NC ANG Security Forces Building
Charolotte, NC

Addendum 01

New Security Forces Building

for
North Caroline Air Nation Guard
124th fighter wing
Charlotte, NC

1 ONE-LINE DIAGRAM
E601 NTS

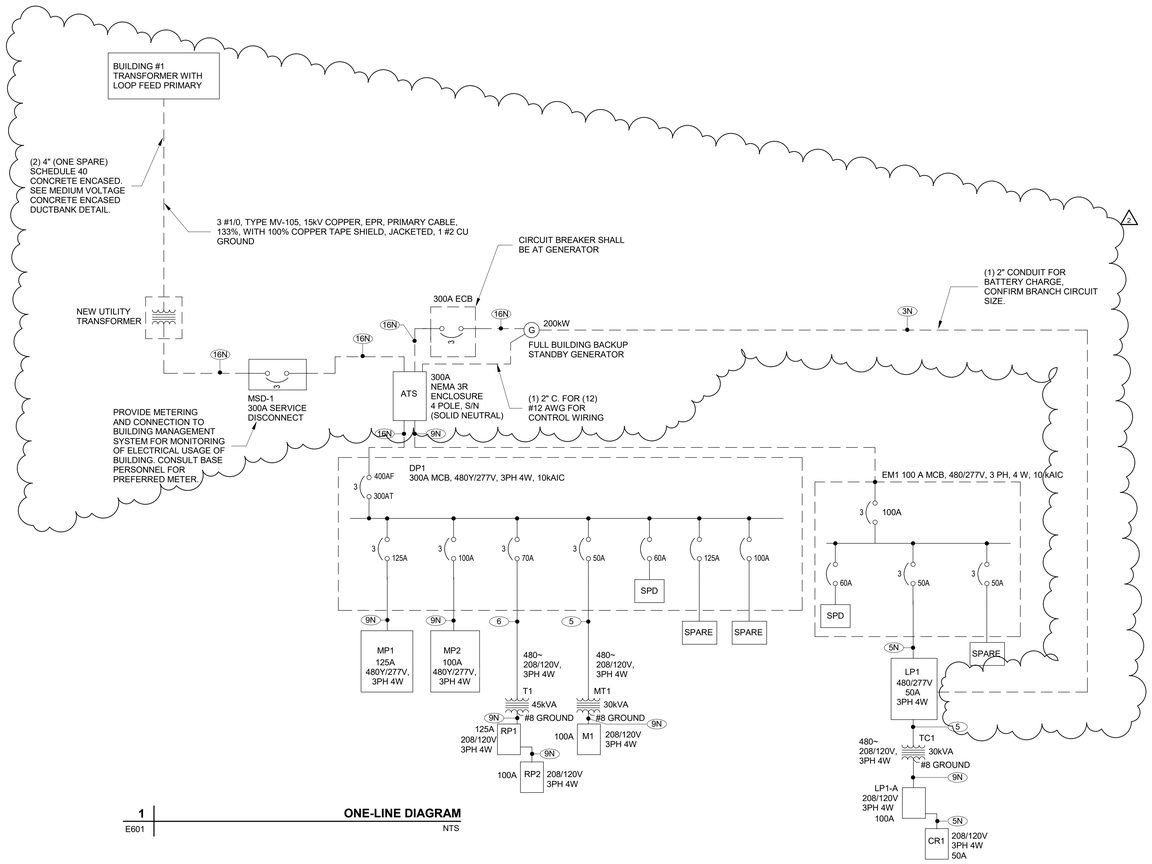
15. Drawing E601 ELECTRICAL ONE-LINE DIAGRAM
   a. Remove utility meter and CT cabinet, call for metering at the Main Service Circuit Breaker, added conduits for Medium Voltage feeder from Building #1 transformer, primary loop connections. Show conduits ATS to Generator control wiring, and Battery Charger feed. Changed the Distribution Panel Schedule EM1 to a 100 amp Main Circuit Breaker and 100 amp buss.

1 T101 **01 FIRST FLOOR**

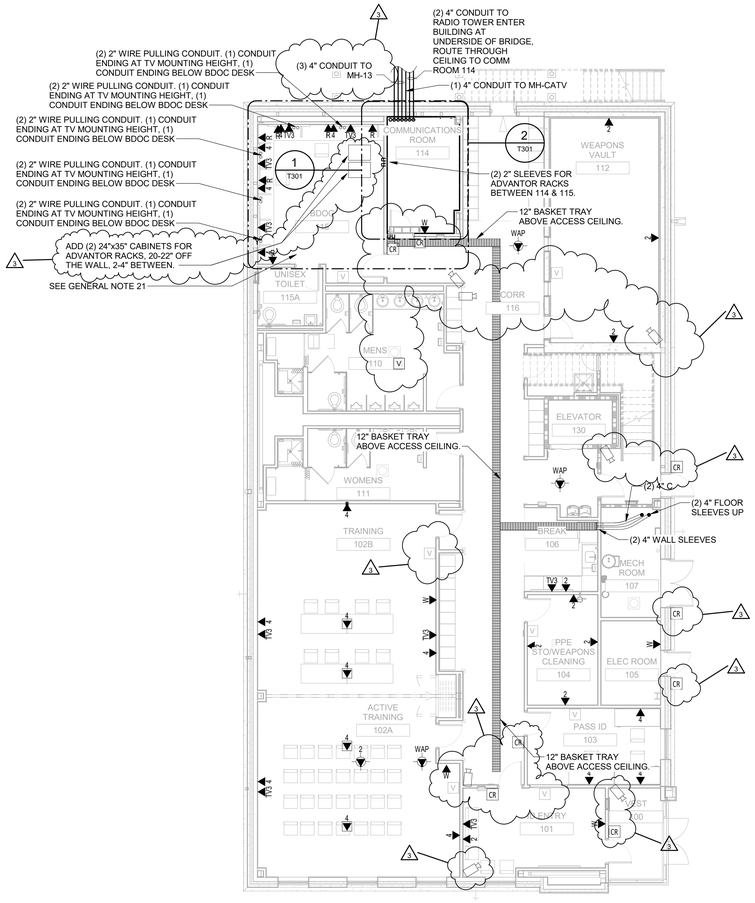
18. Drawing T001
   a. Notes and annotations were added for cameras, access control and public address system.
19. Drawing T101
   a. Changes to OSP conduit notes.

b. Added annotations for cameras, PA and access control systems.
20. Drawing T102
   a. Added annotations for cameras, PA and access control systems.
21. Drawing T200

1 T200 **TELE SITE PLAN - OVERALL**

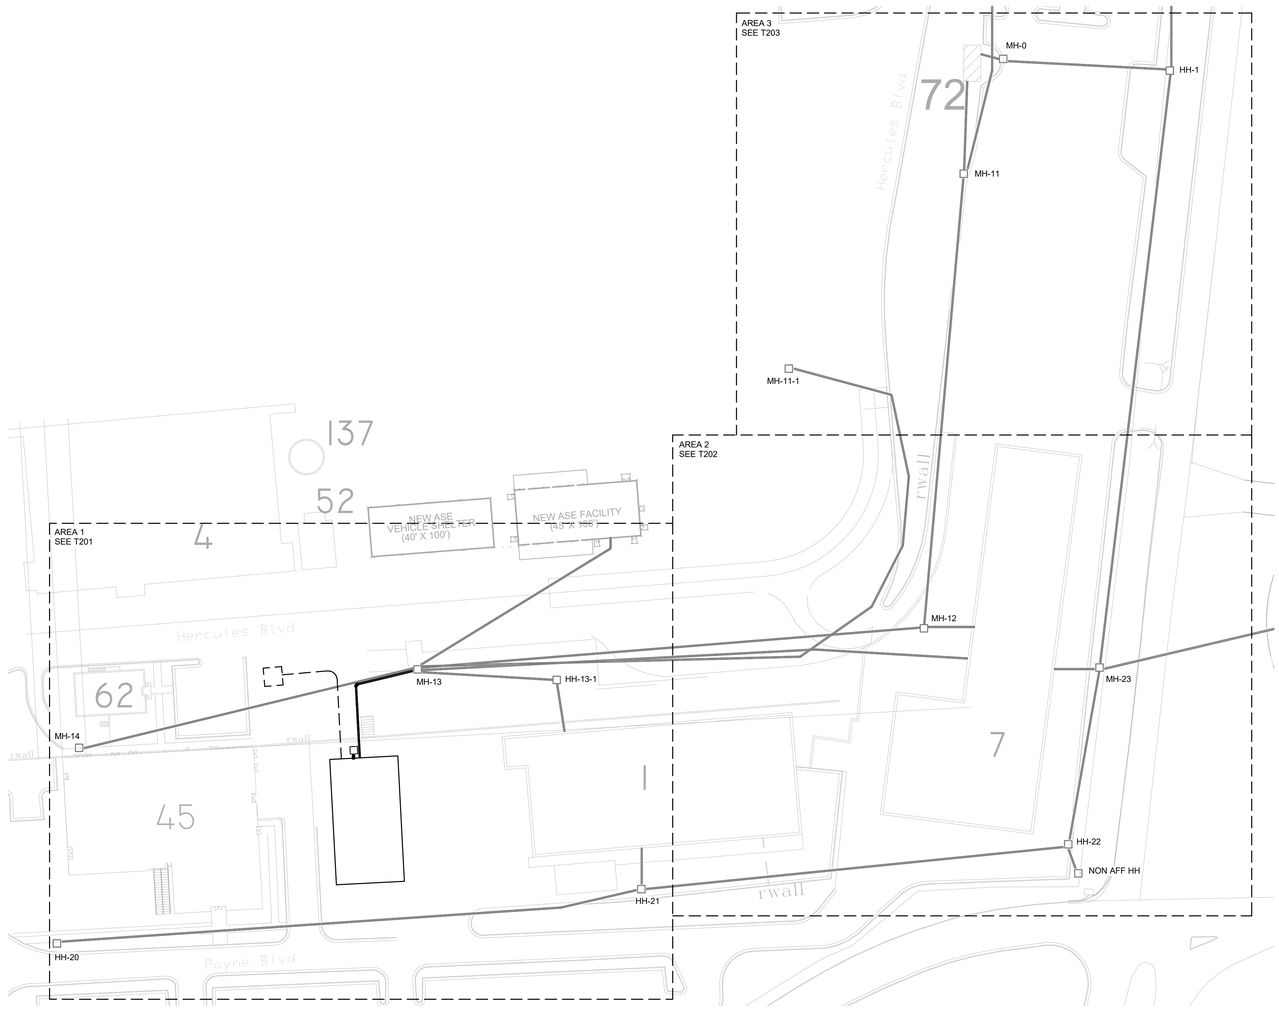
a. Sheet was added to show OSP ductbank routing.
22. Drawing T201
   a. Sheet was altered to show OSP ductbank routing.
23. Drawing T202
   a. Sheet was added to show OSP ductbank routing.

3 T301 **RACK ELEVATIONS**
Scale: 1" = 1'-0"

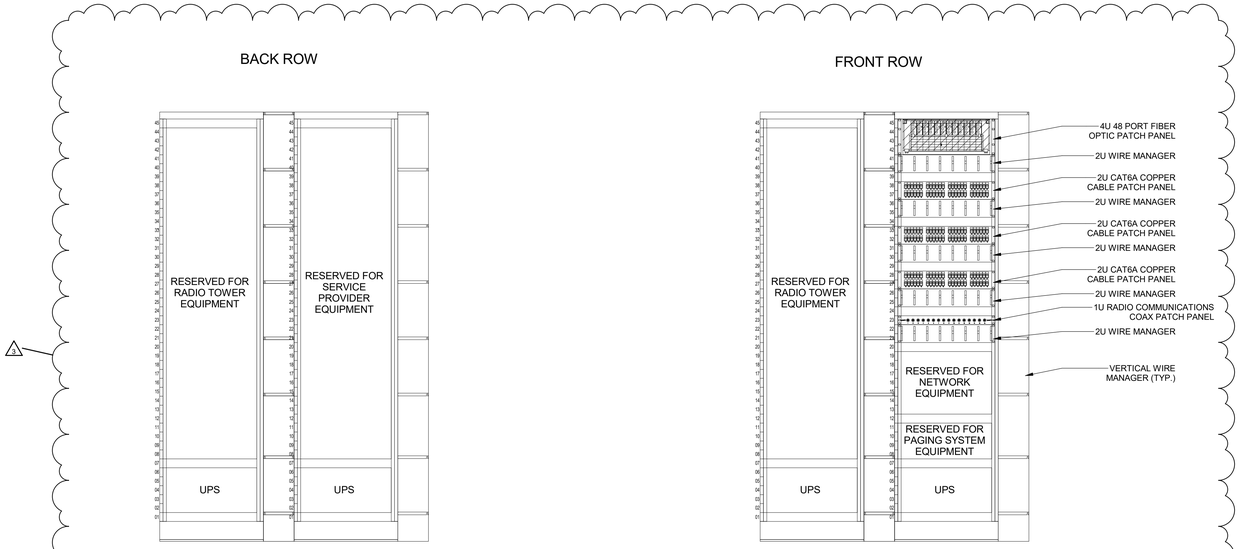
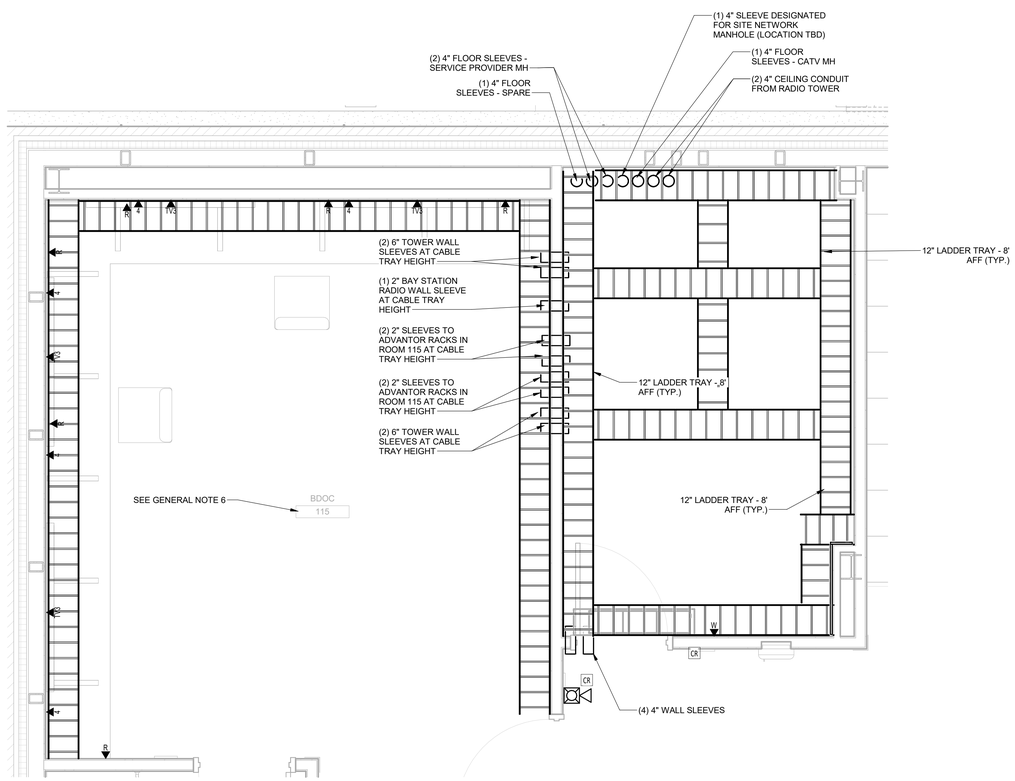
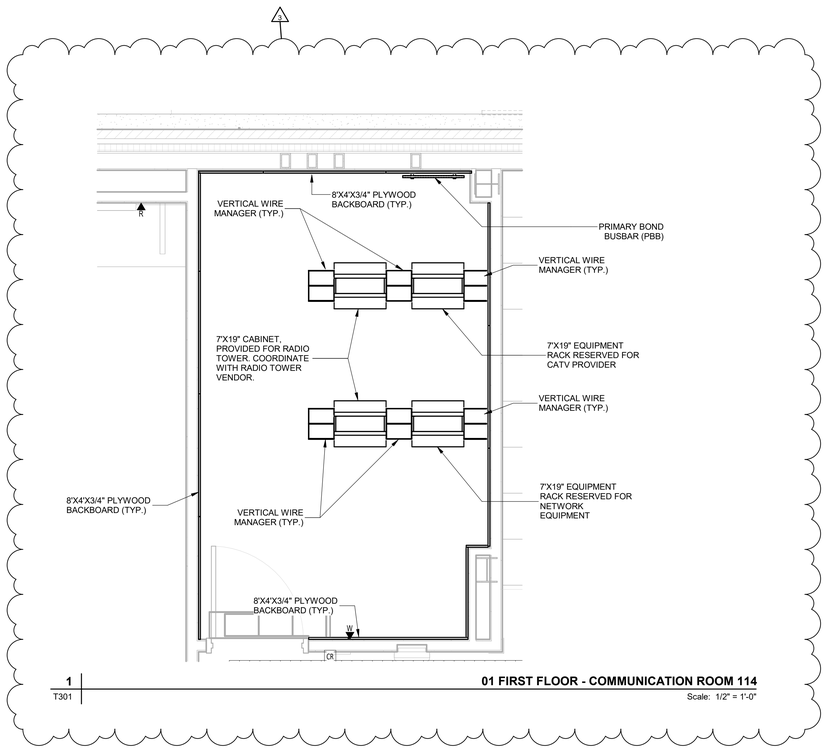
24. Drawing T203
   a. Sheet was added to show existing ductbank routing.
25. Drawing T301
   a. Sheet was altered to show changed TR layout and rack layout.

1 T503 **3-WAY CONCRETE ENCASED DUCTBANK**

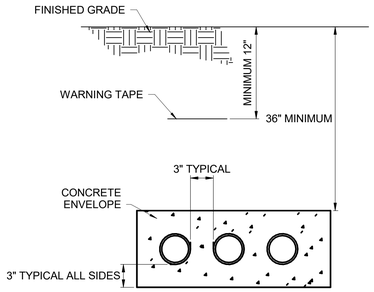
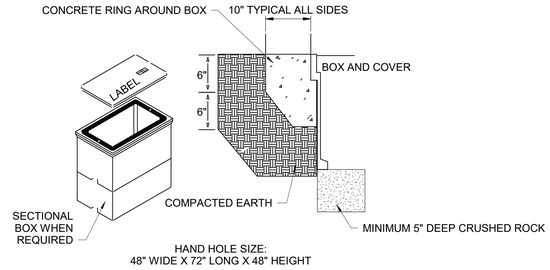
26. Drawing T503
   a. Sheet was added to show telecom site details.

1 T601 **TECHNOLOGY RISER DIAGRAM**

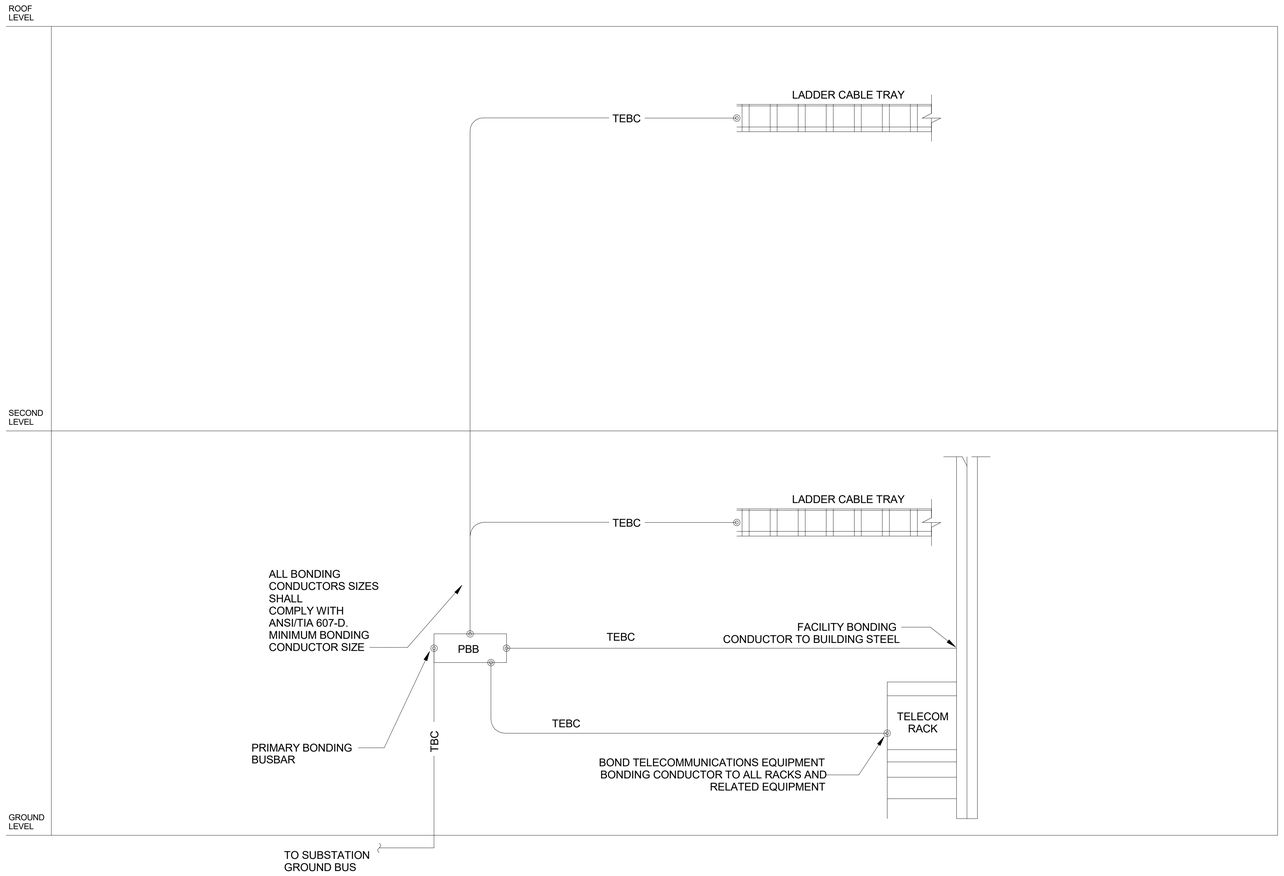
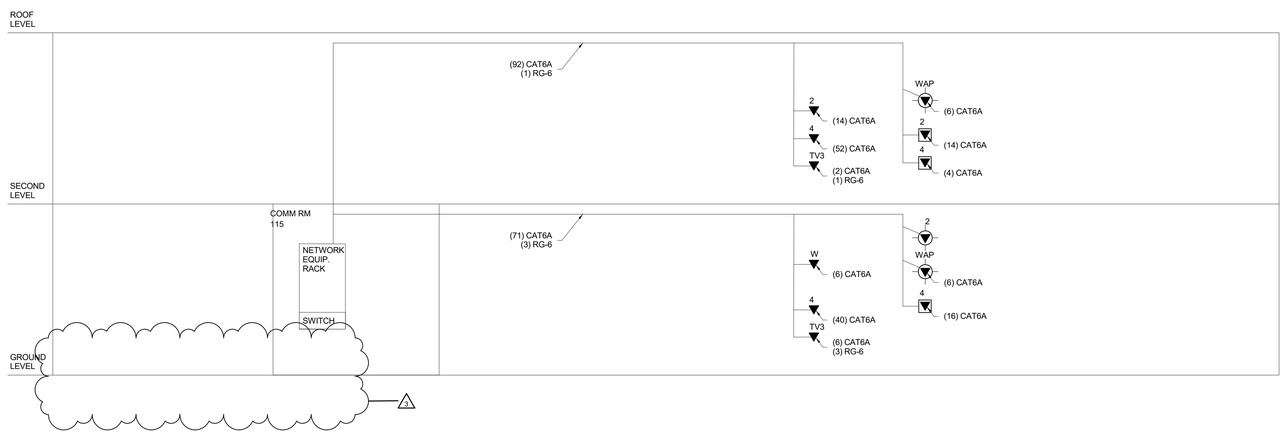
27. Drawing T601
    a. Service provider note was removed.
28. Drawing T602
    a. Sheet was added to show proposed OSP routing.
